**HISTORIC PRESERVATION BOARD AGENDA
CITY HALL AUDITORIUM, 250 NORTH 5TH STREET
TUESDAY, APRIL 4, 2023 - 4:00 PM**

Project Name: Certificate of Appropriateness (COA) – Conversion of Existing Garage to Short Term Rental
Applicants: Thomas and Melinda Watson, Owners
Representative: Thomas Watson
Address: 417 North 7th Street
Staff: Kristen Ashbeck, Principal Planner
File No. COA-2023-142
Date: April 4, 2023

Project Name:	Certificate of Appropriateness (COA) – Discovery Kids New Daycare Building
Applicants:	Western Colorado Outside LLC
Representative:	Discovery Kids Learning Center - Kirk Huddleston, Owner
Address:	715 North 7 th Street
Staff:	Kristen Ashbeck, Principal Planner
File No.	COA-2023-165
Date:	April 4, 2023

Proposed
North Elevation
Garage

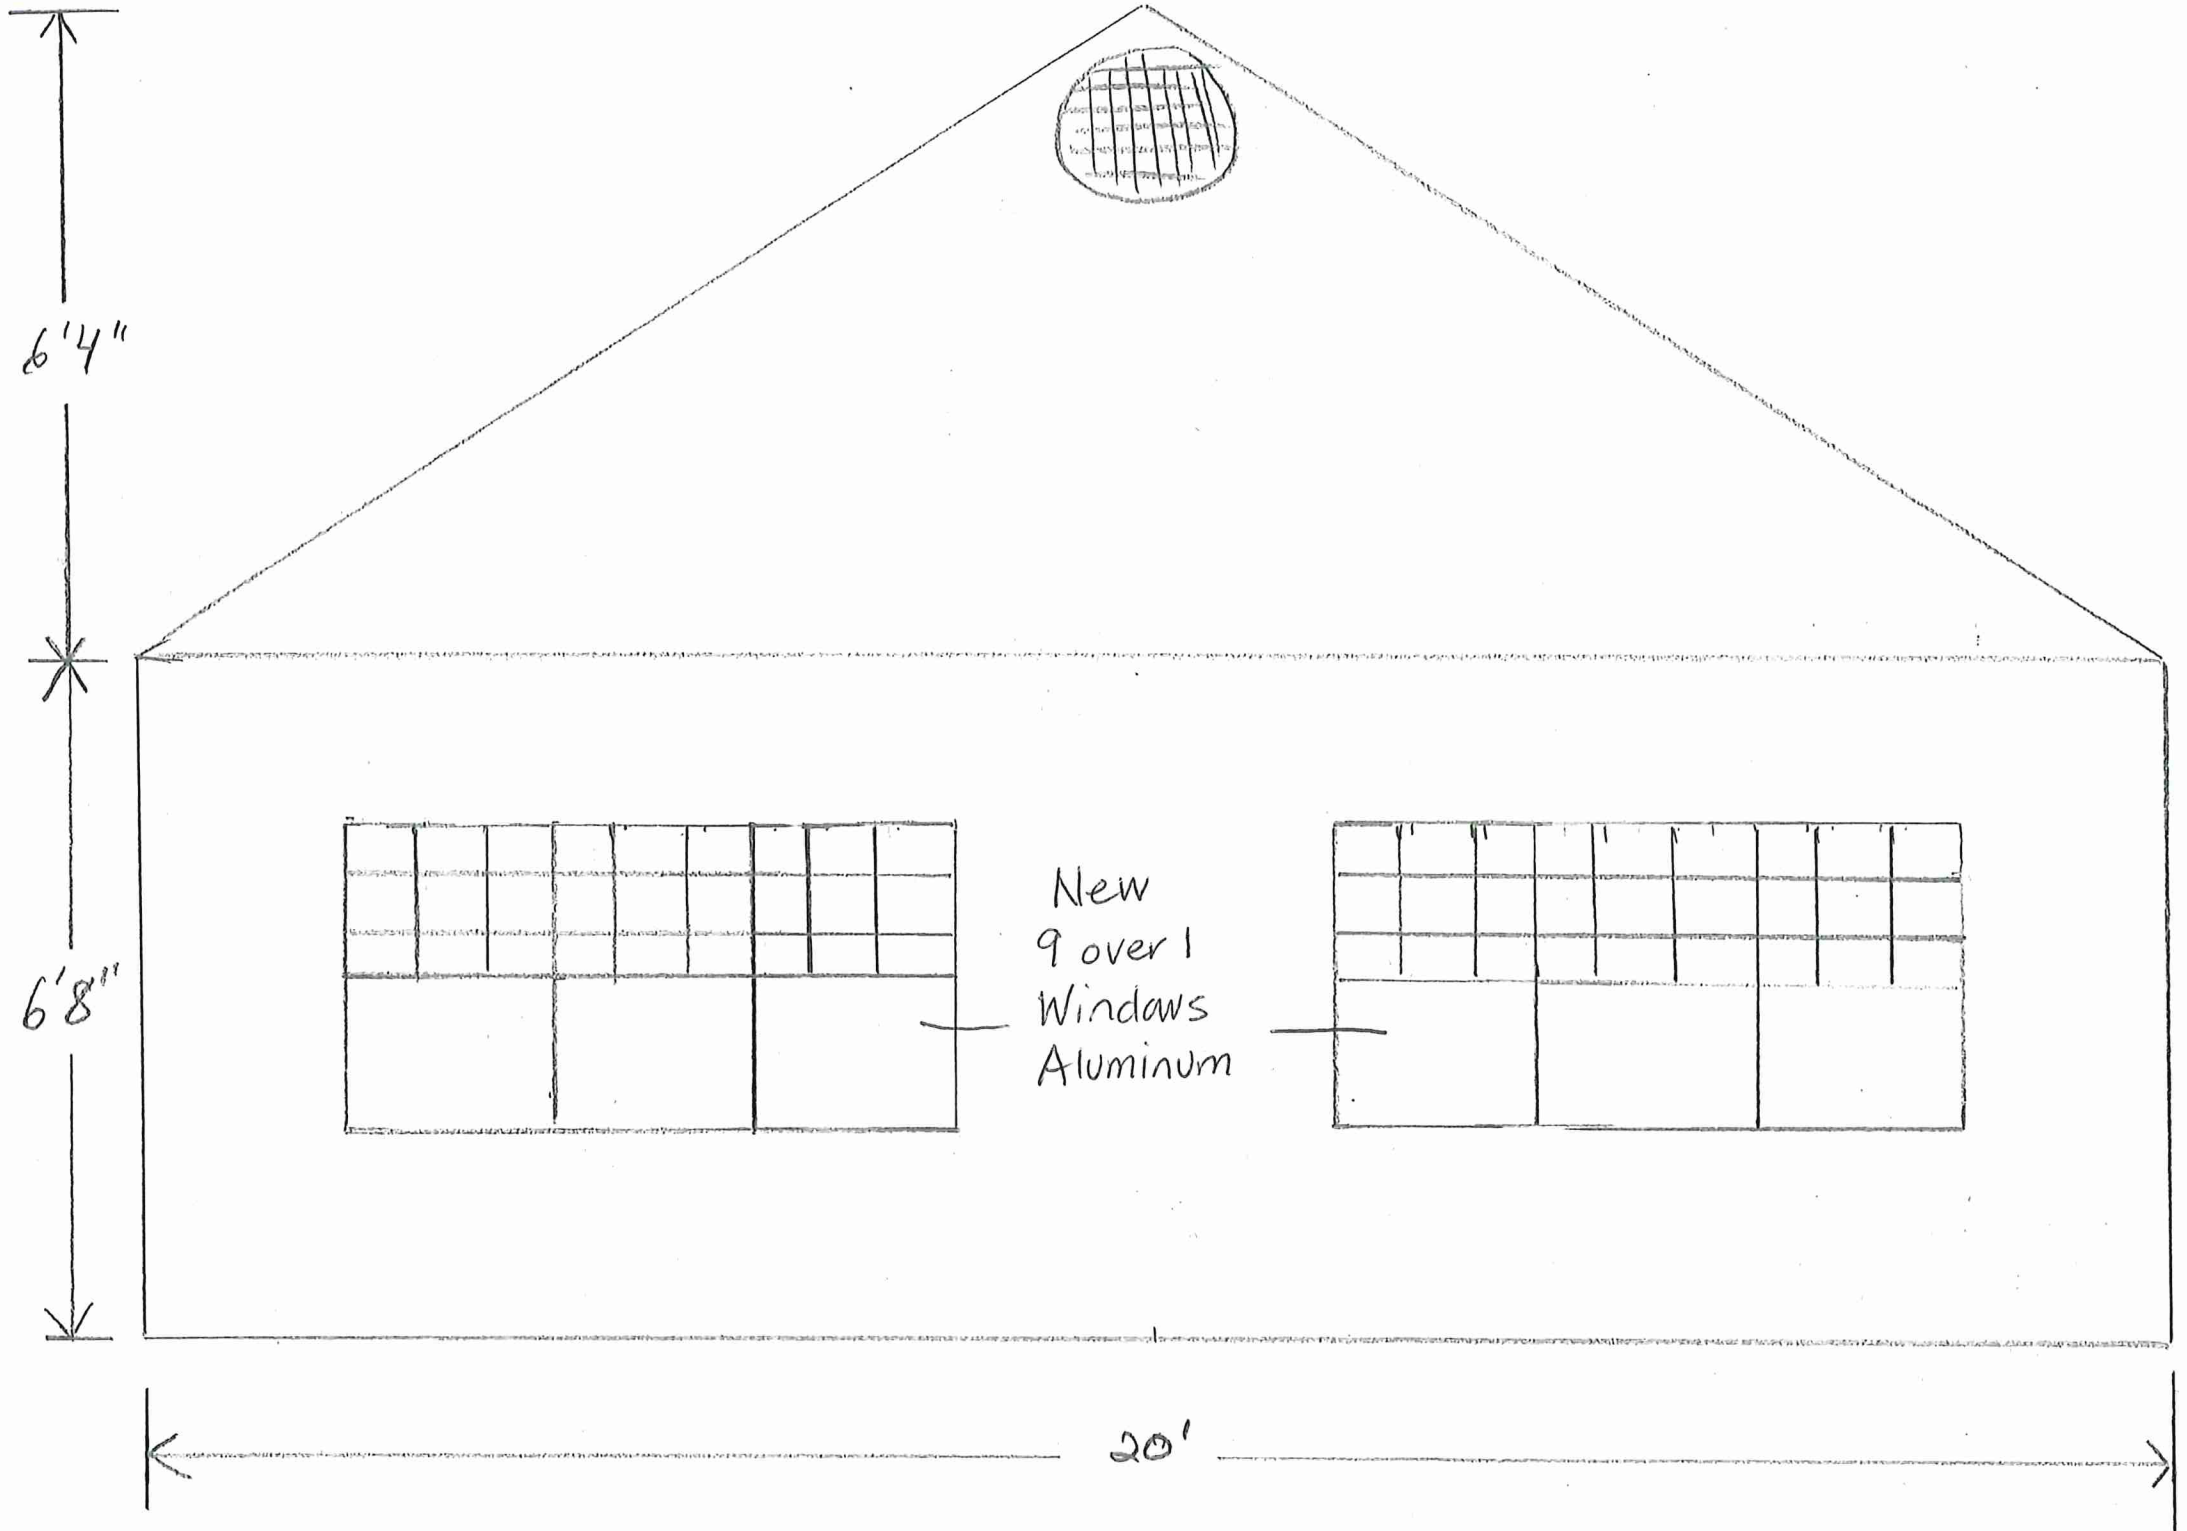
Staff Analysis: The windows and façade treatment on the proposed garage remodel are to be consistent with windows on the existing structure with aluminum double-hung windows that will have a sill depth of 2 to 4 inches to have some depth and visual relief on the facades. The proposed windows will have 9 panes over 1 pane to match the main windows on the existing home. Thus, staff finds these guidelines have been addressed.

Proposed
South Elevation
Garage

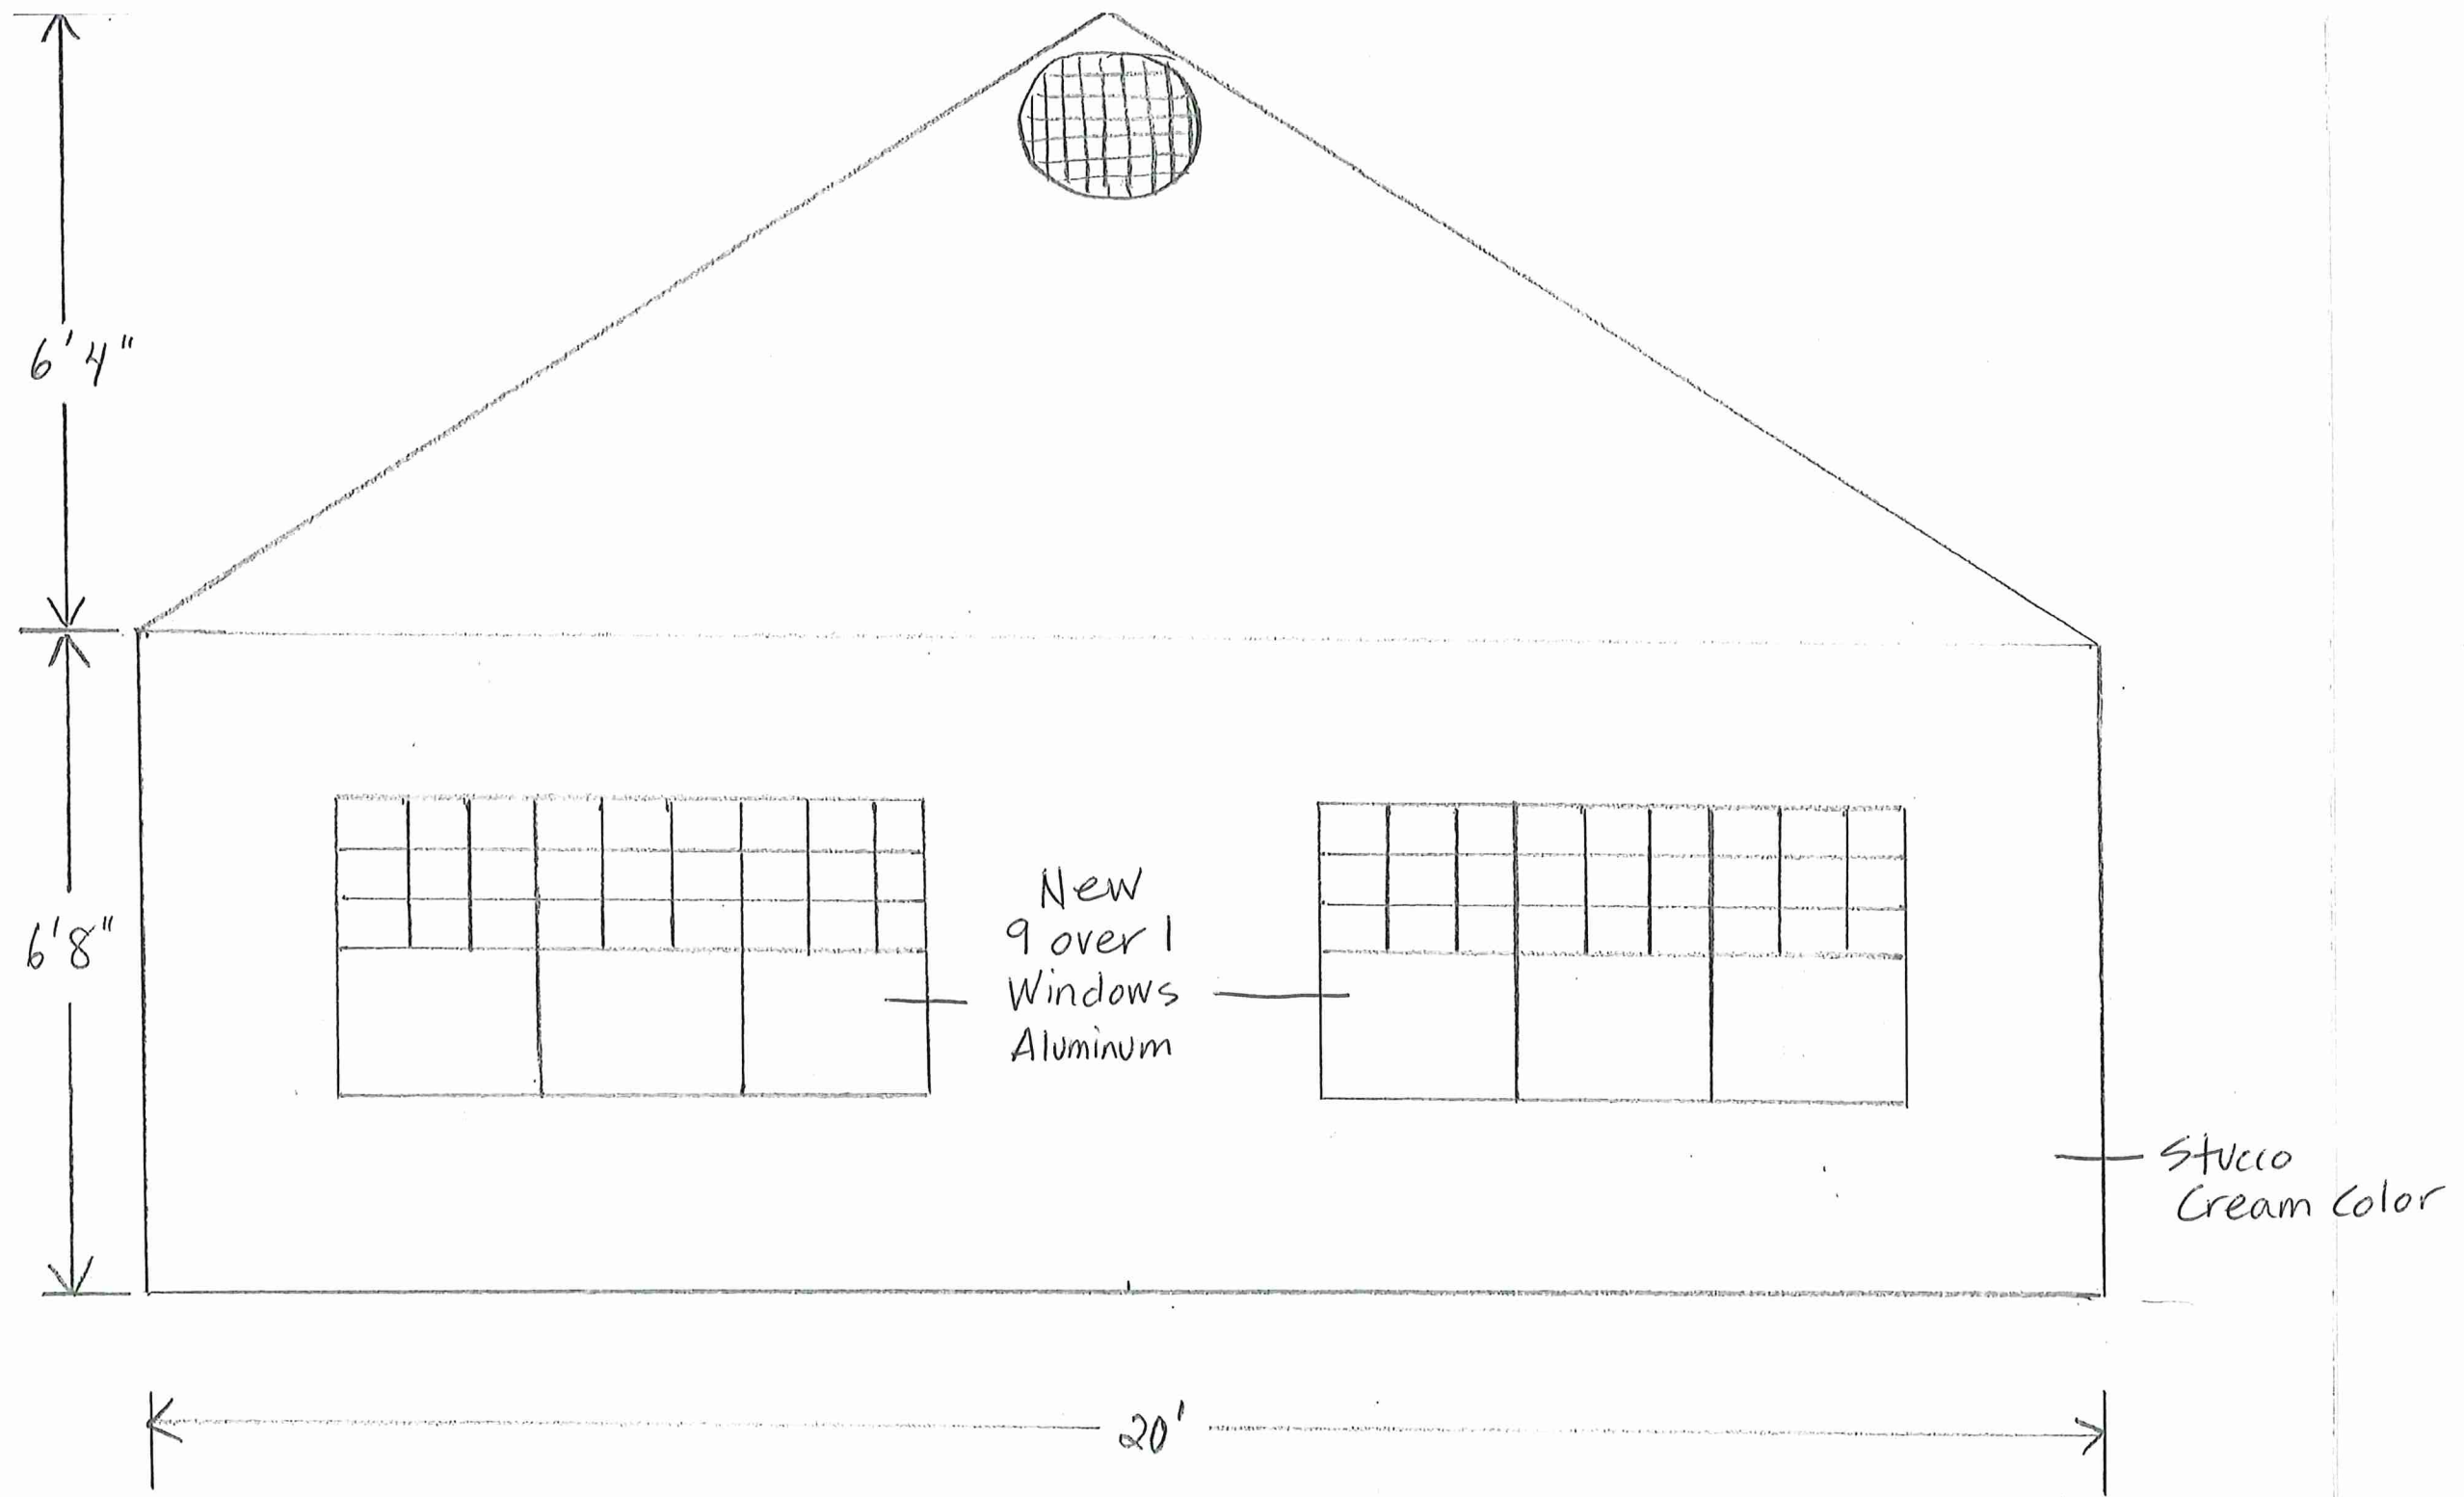
Staff Analysis: The existing cladding on the garage is wooden lap siding. With this remodel, the applicant is proposing that the building exterior be finished in stucco. While this is a change to the exterior building materials, stucco is listed as a material found in the District and it will match the stucco siding on the existing home. Thus, staff finds these guidelines have been met.

Aerial Photo of Site

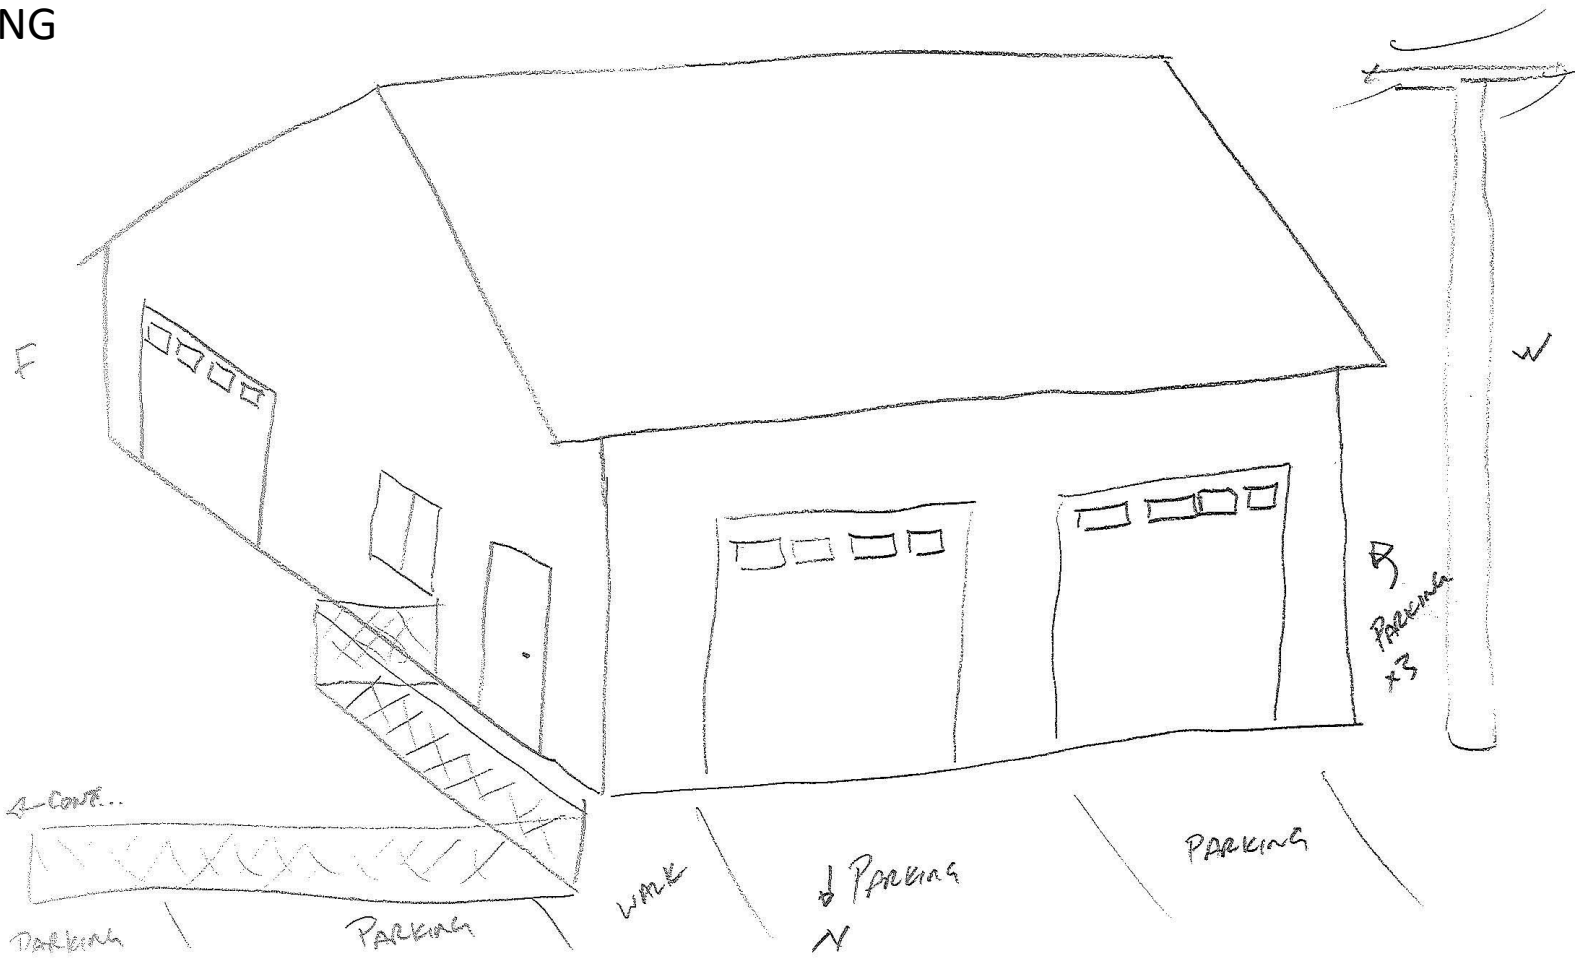
Staff Analysis: The site plan depicting the proposed and relocated buildings show that both the new building and the relocated structure will meet the side yard (3 feet) the rear yard (5 feet). The proposed height of the new building at its peak is 20 feet while the relocated structure will remain 15.75 feet at its highest point. Therefore, staff finds the bulk standards for an accessory structure have been met.
